Service Bulletin

Bulletin No.: 25-NA-101

Subject: Information on Airbag Light on with DTC U3000.7B and/or U3000.49 set in the Passenger Presence Module

6903655

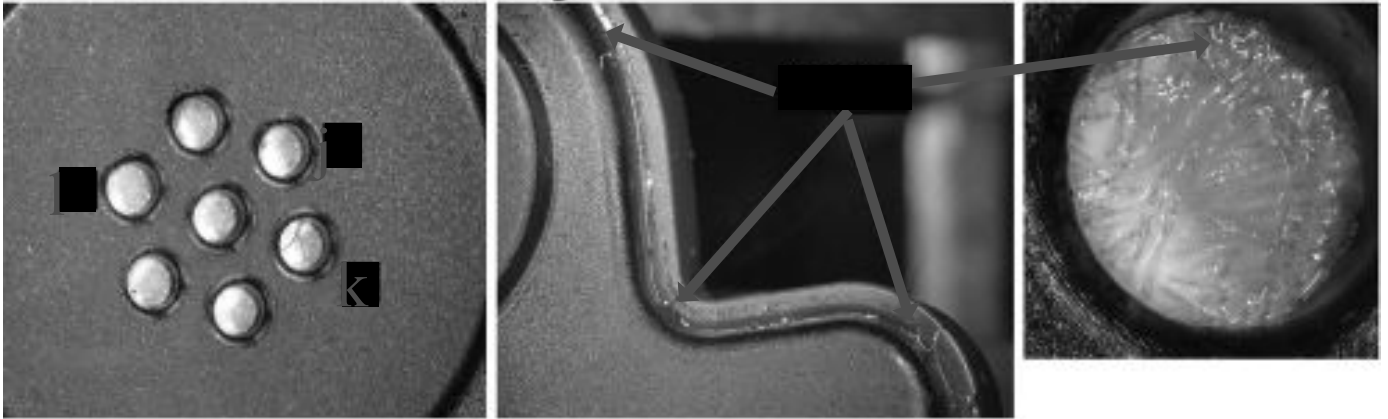
Replace the contaminated Passenger Presence Module. Contaminated pictures are shown above with clear liquid residue shown in pictures. Refer to *Airbag Front Passenger Presence Module Replacement* in SI.

Correction	Replace the contaminated passenger presence module. And use care when cleaning near the module reference port.
